PROJECT : NEW DELHI INTERNATIONAL AIRPORT PHASE-3A DEVELOPMENT WORKS

TITLE: ARFF5 MEGADOOR 5800 X 5360 (RS6)

DRAWING No. DIAL-LT-Q-UTL-A-10-103

SHOP DRAWING
Building: ARFF5

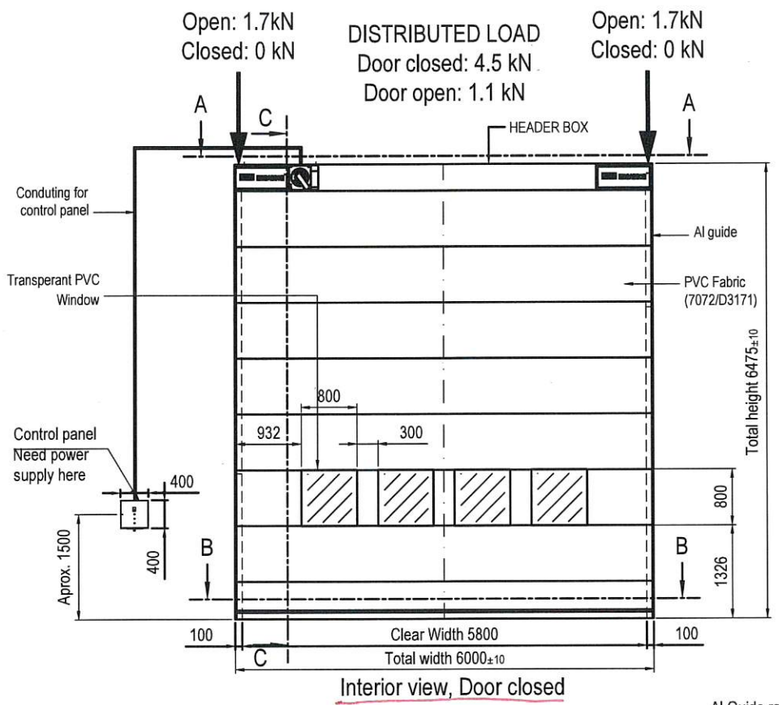
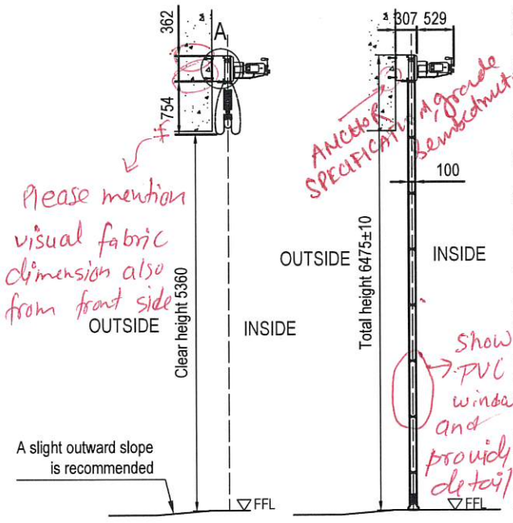
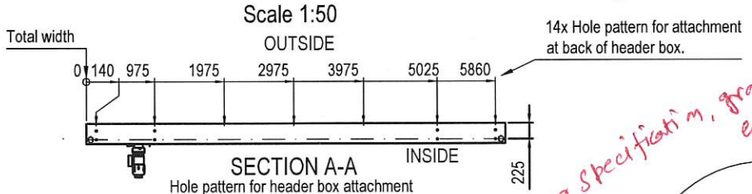
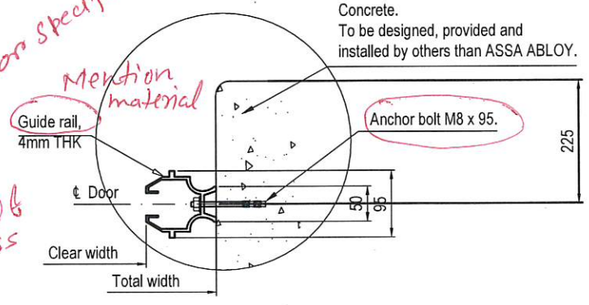
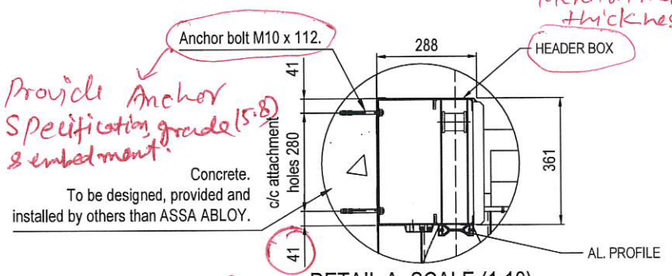
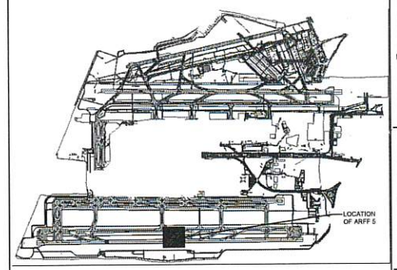
Add note for manual override operation

Please mention visual fabric dimension also from front side

Fabric colour as per DIAL Approval

All dimensions / sizes shown in drawings to be verified at site by Vendor prior to proceeding to Production.

All material / finishes are subject to MAS / sample approval by DIAL.

Please submit the final shop drawings to DIAL for Approval.

Anchor specification, grade (5.8) embedment

Mention material & thickness

Mention material & thickness

Provide Anchor Specification grade (5.8) & embedment

min edge distance 55 mm.

(i) Wiring Diagram & control scheme to be provided.

(ii) Show all control boxes in overall plan.

TITLE: ARFF5 MEGADOOR 8760 X 4988 (RS7)
SCALE 1:50
DRAWING No. DIAL-LT-Q-UTL-A-10-104
SHEET:
PROJECTION FIRST ANGLE
SIZE A3
REV B

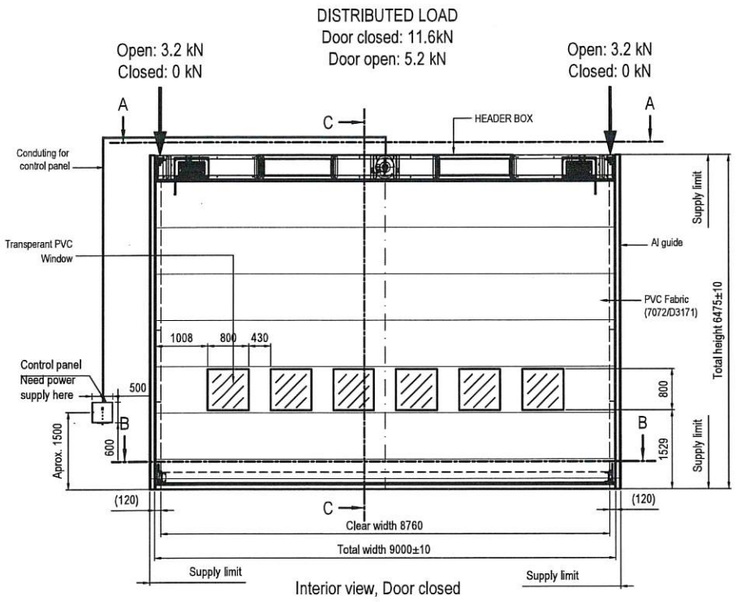
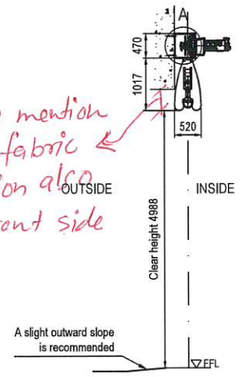
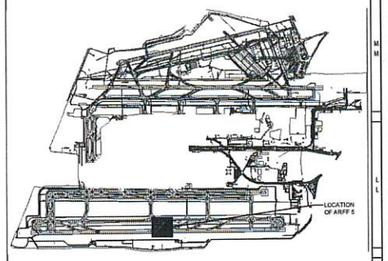
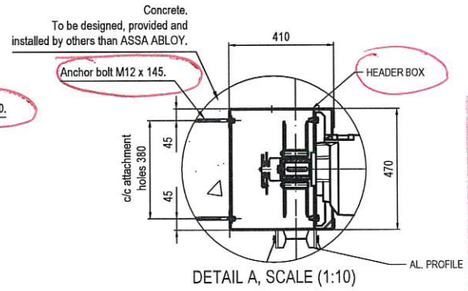
Refer comments provided on drwg no A-10-103.

please mention visual fabric dimension also from front side

Add note for Manual overside operation

Show the actual column position from plan

DRAWING No. DIAL-LT-Q-UTL-A-10-101

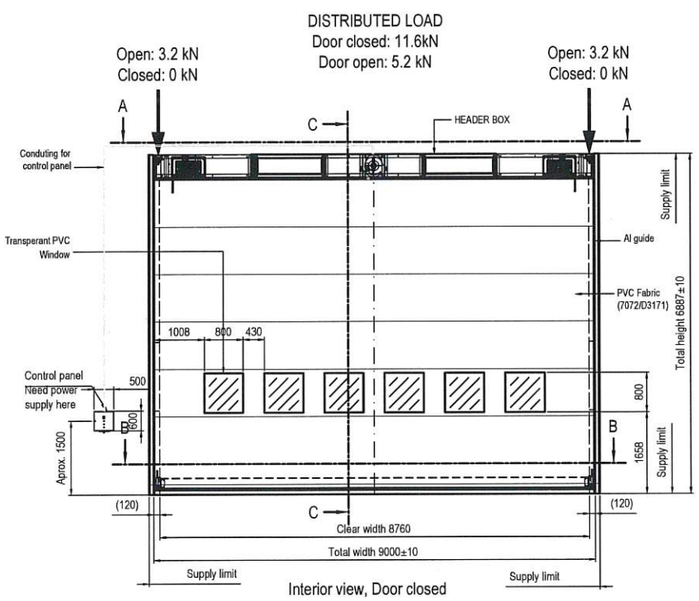
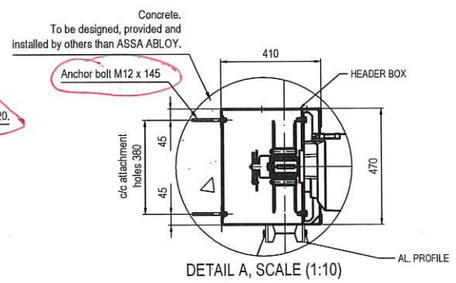
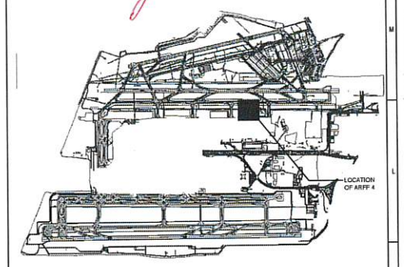
Refer general comments provided on drwg. no. A-10-103.

DRAWING No. DIAL-LT-Q-UTL-A-10-102

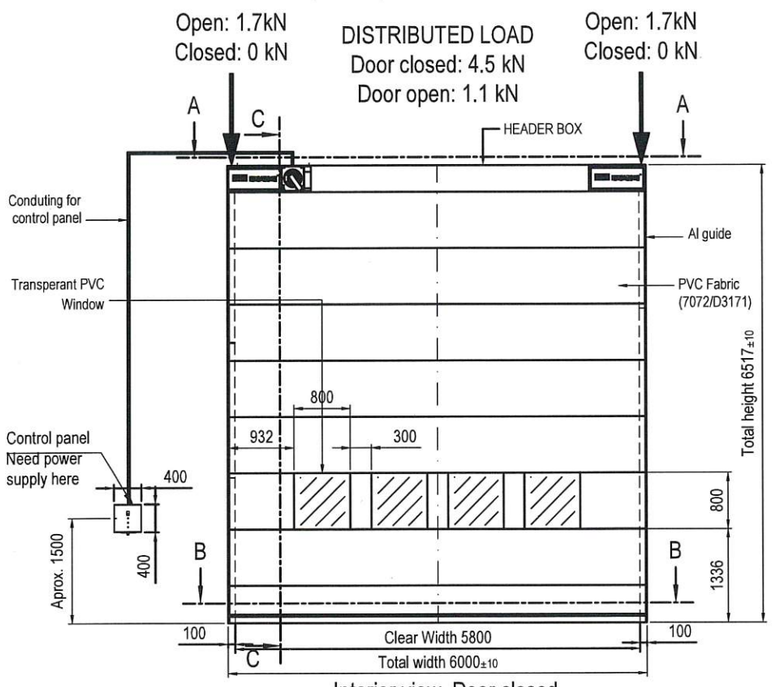
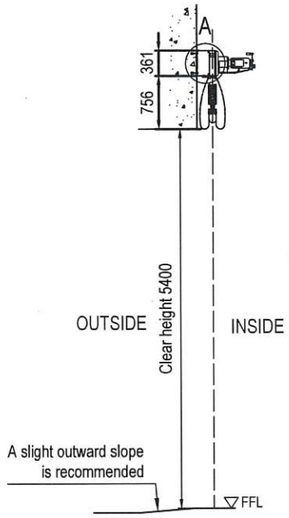
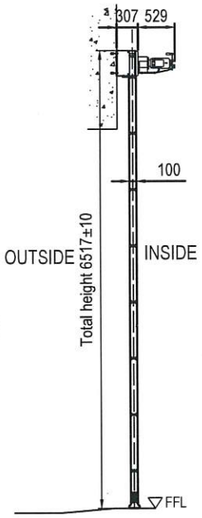
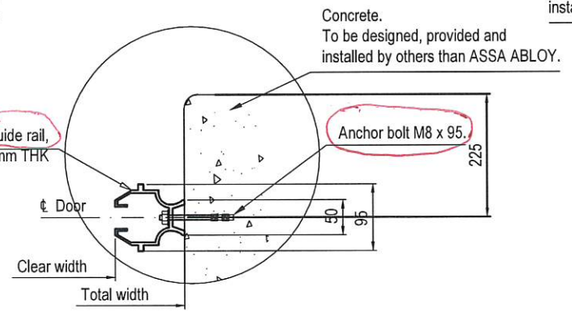
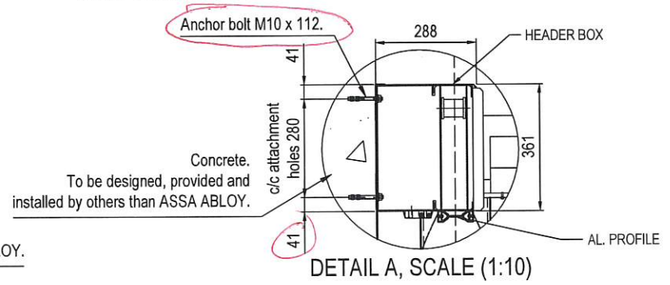
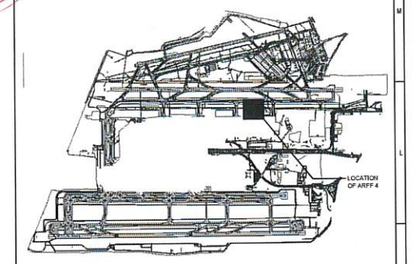
Refer general comments provided on drwg no A-10-103
